Meridian Green Works, LLC

PLAYA DRAIN TRAIL - ADDENDUM #2

TO: Prospective Bidders **DATE:** November 21, 2017

This Addendum forms a part of and modifies the bid documents dated October 24, 2017 as indicated below:

SITE PREPARATION ORIENTATION PLAN

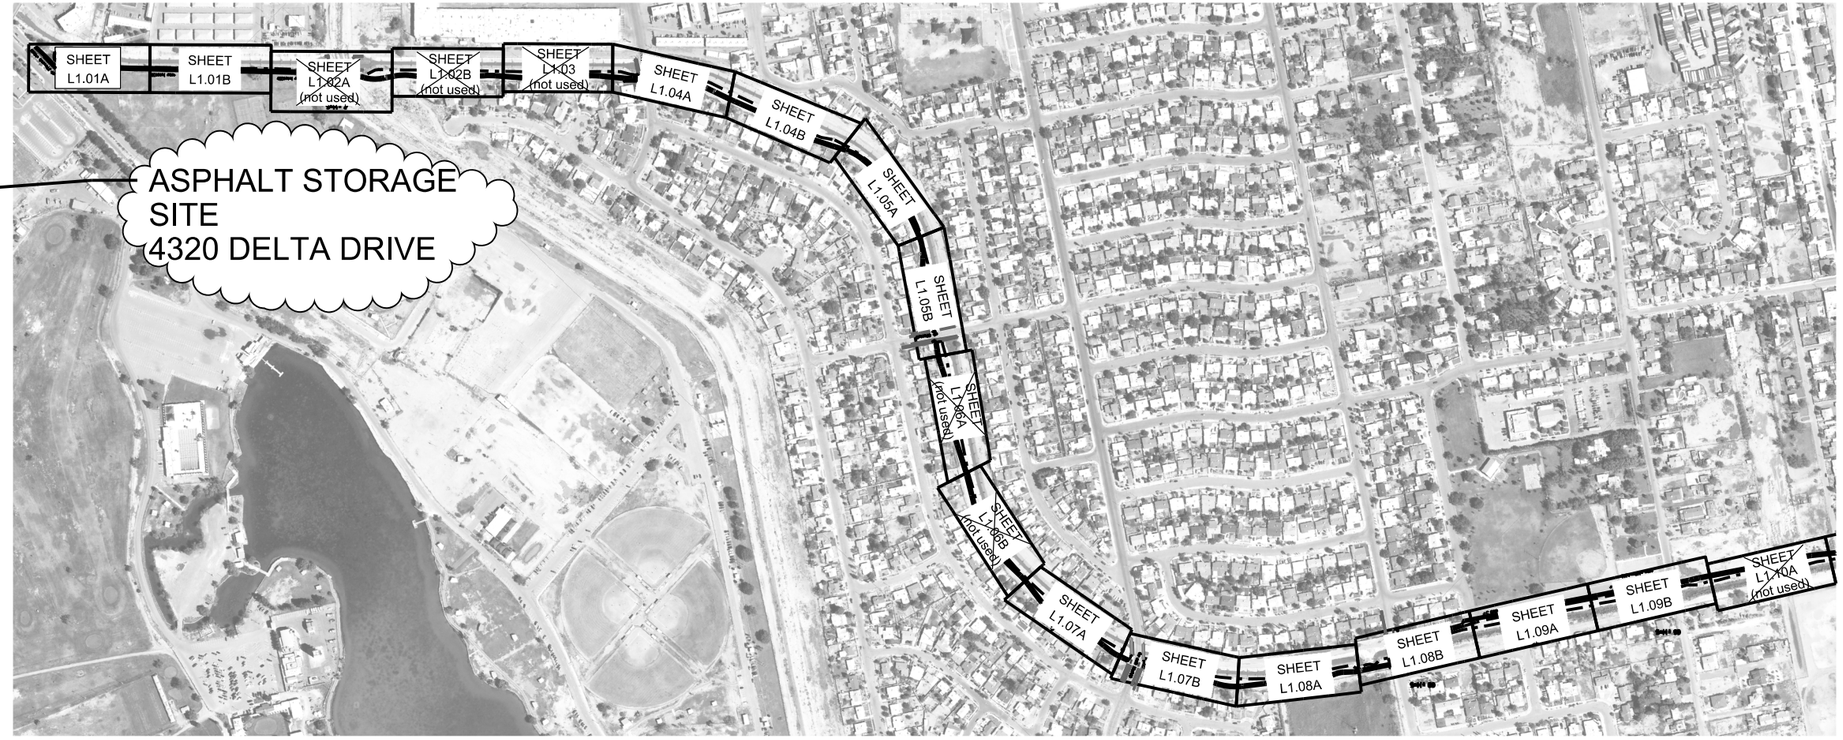
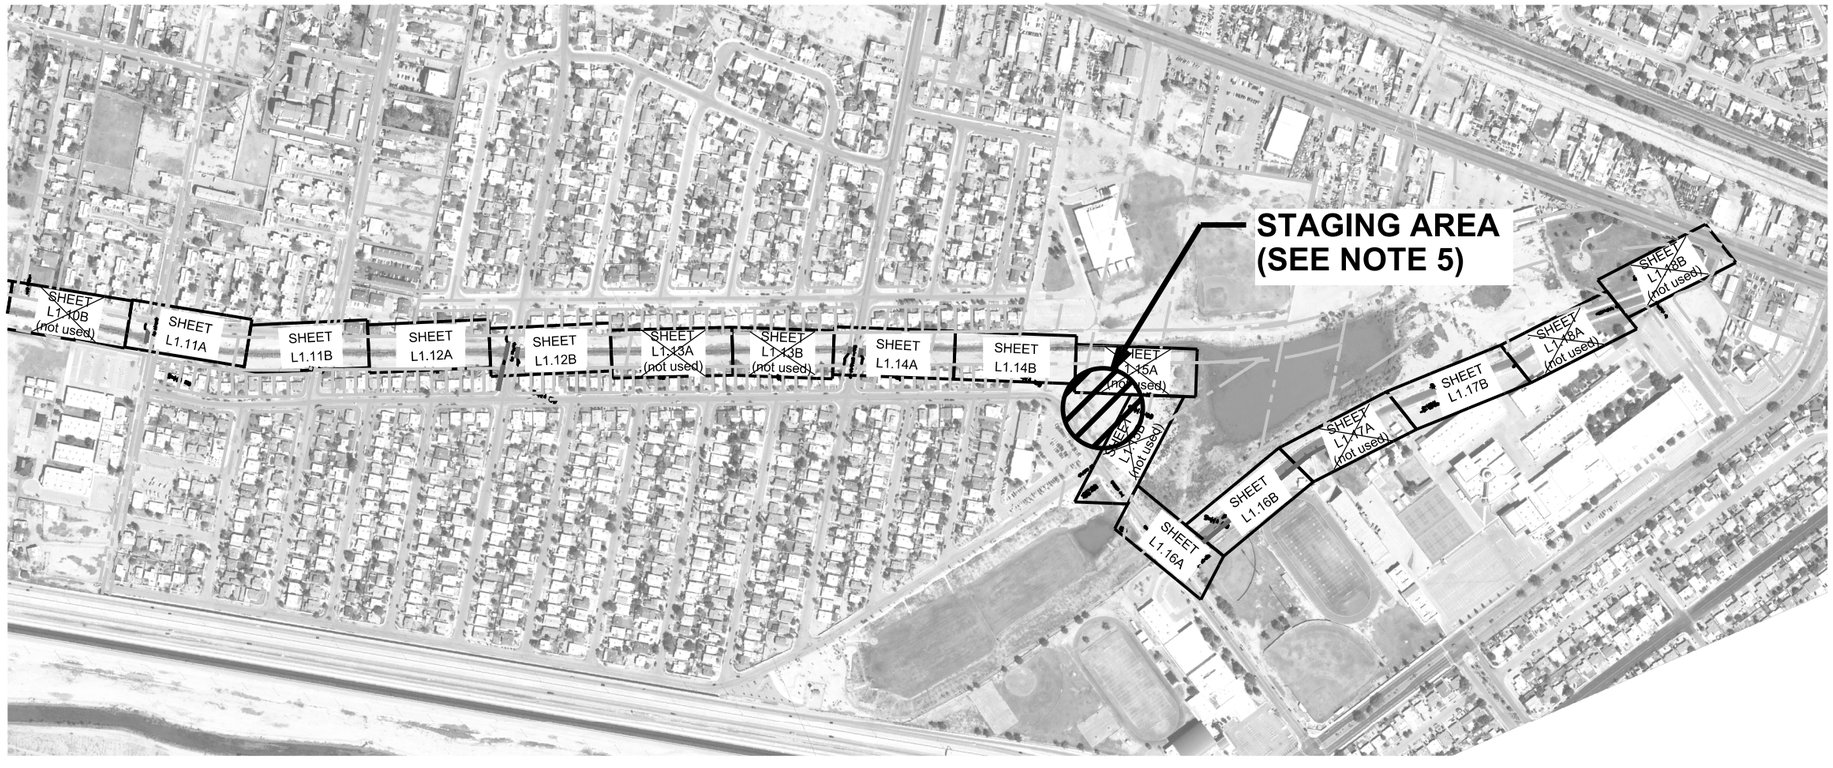
1. Delete the following plan sheets in their entirety, and replace with new plan sheets attached to this addendum:
   A. Sheet L1.00 – Site Preparation Orientation Plan
   B. Sheet L1.01 – Site preparation Plan
   C. Sheet L3.01 – Landscape Plan
   D. Sheet L3.18 – Landscape Plan
   E. Sheet L5.06 – Hardscape Details
   F. Sheet L5.07 - Hardscape Details
   G. Sheet L5.10 - Hardscape Details
   H. Sheet C3.16 – Grading and Drainage Plan
2. Revise the name of Sheet L5.14 to LANDSCAPE DETAILS.
3. Revise the name of Sheet L5.15 to IRRIGATION DETAILS.
4. Insert Sheets 1 of 2 and 2 of 2, SAFETY END TREATMENT,, TXDOT standard detail sheets, after sheet C1.03 in the plan set.

Sheet Title
HARDSCAPE DETAILS

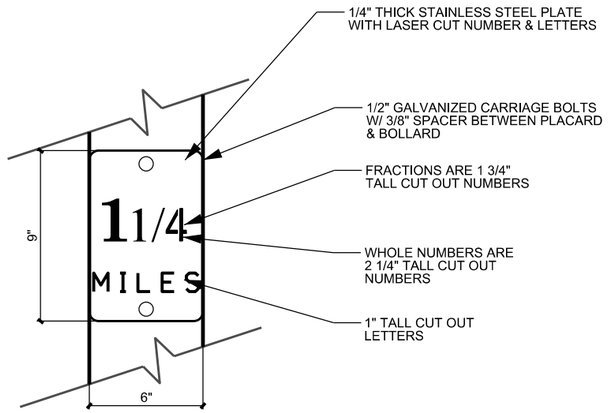
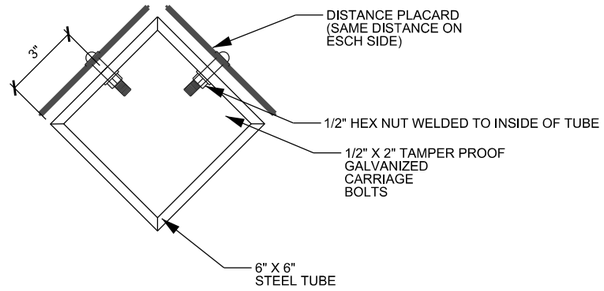
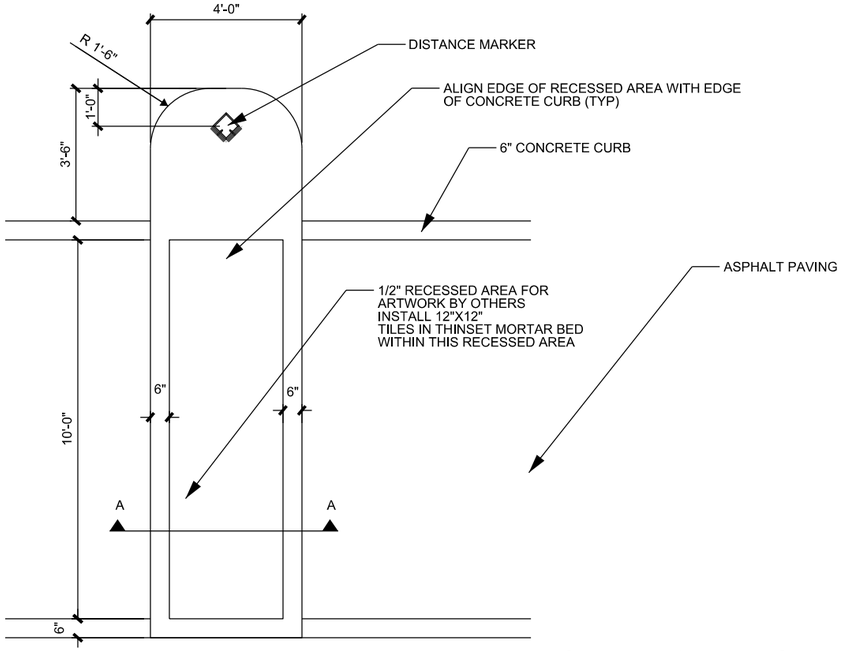
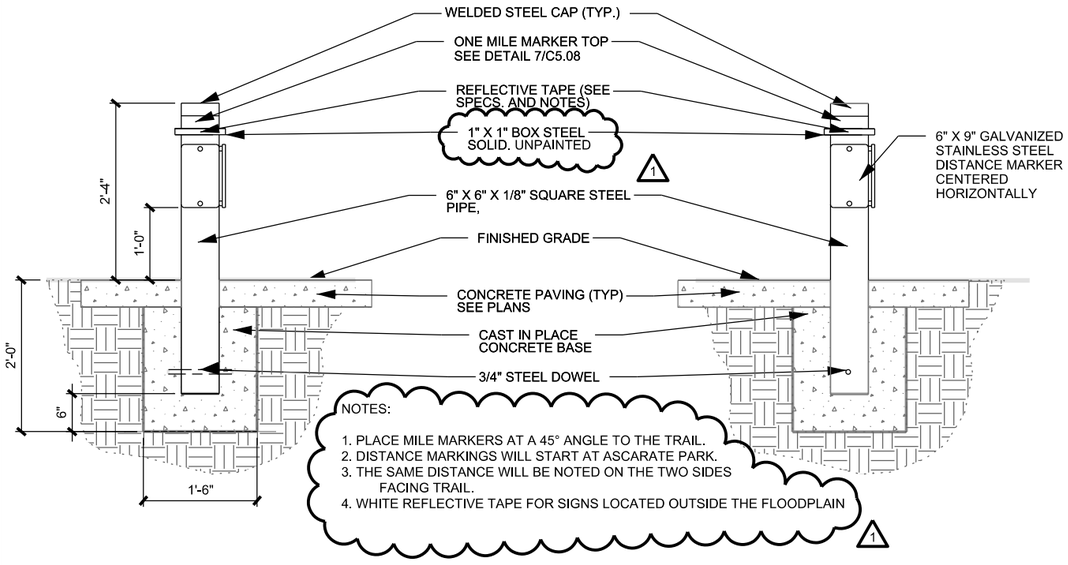
3. Please clarify Artistic Tiles to be installed.

ANSWER: The Owner will supply Artistic Tiles that are approximate 12" x 12" nominal dimensions, which will be installed in recessed areas in the paving adjacent to the Distance Markers that occur along the trail. The Artistic Tiles will be installed in a thinset mortar bed and grouted with exterior grade grout.
